Logos Apparels Ltd. (Building 4)

25th November 2020

1. Production Building (Building 4) (B+G+5)

Observations

Column P-M-M interaction ratio found from FEA model on ETABS

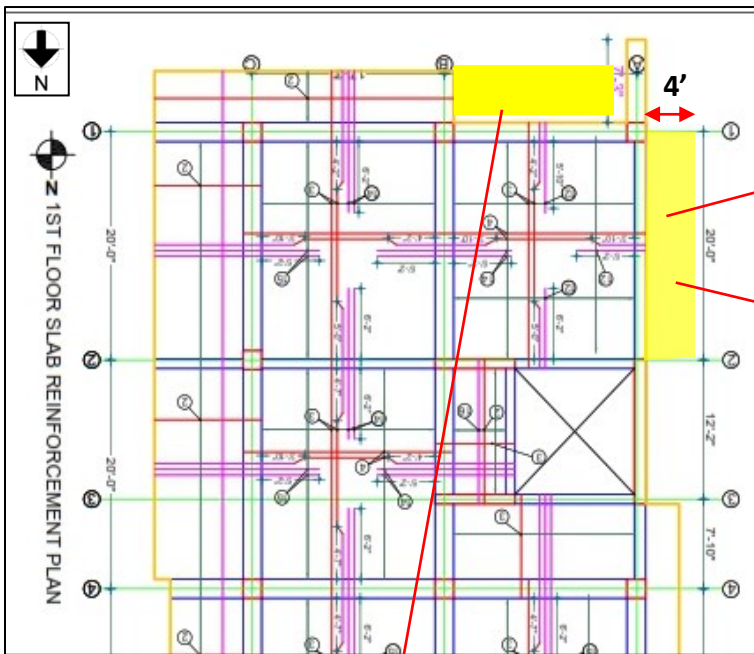
As per drawing the C04 column has 20 number of rebar but on the sectional property of C04 column on FEM, 14 number of rebar has been assigned.

There was no design report available for this structure on site, during inspection. Factory only provided the FEA model of this structure. During FEA model check, some columns were found overstressed. Factory is required to revise the FEA model. Also, the steel part (ACP works) loading of the roof has not been assigned. Building Engineer to prepare design report as per BNBC (part-6; Article 1.9.1) by reviewing design, loads and capacity of structural members.

Item No.	Observation	Recommended Action Plan	Recommended Timeline
01	Design report need to be prepared	Building Engineer to prepare design report as per BNBC (part-6; Article 1.9.1) by reviewing design, loads and capacity of structural members.	6-weeks
02	Design report need to be prepared	Produce and actively manage a loading plan for all floor plates within the factory, considering floor, column and foundation capacity.	6-weeks
03	Design report need to be prepared	Complete implementation of any remedial works deemed necessary by the Design Report.	6-months
04	Design report need to be prepared	Continue to implement loading plan.	6-months
05	Mismatches in As built drawings	Building Engineer to survey the structure and prepare accurate as-built (both architectural & structural) drawings.	6-weeks

Steel Canopy will be built in the marked portion

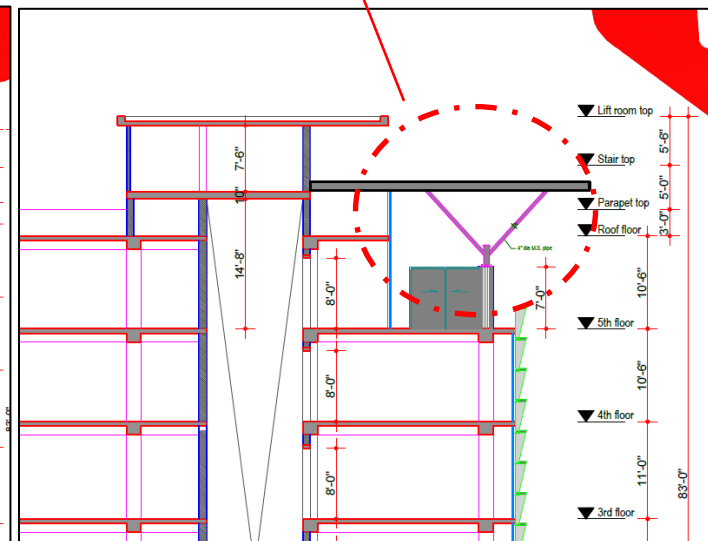
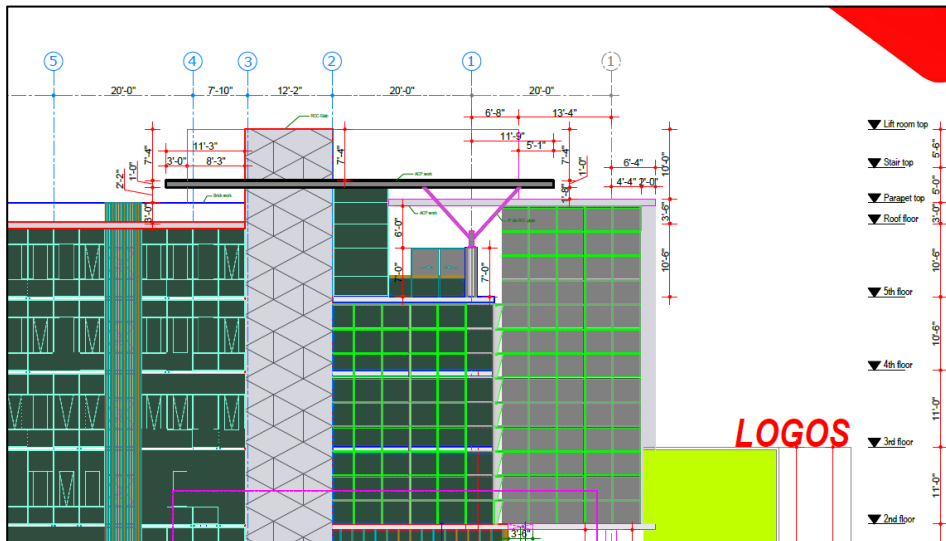
A steel canopy portion will be built in the top floor in future, as per the architectural drawing. But the detailed drawings, connection details of the steel canopy is unavailable.

Item No.	Observation	Recommended Action Plan	Recommended Timeline
06	Drawings of the steel canopy (ACP work) missing	Building Engineer is required produce detailed drawings of the steel canopy and include with as built drawings.	6-weeks
07	Corrosion in Exposed Rebars	Building Engineer is required to remove the corrosions and take preventive measures.	6-weeks
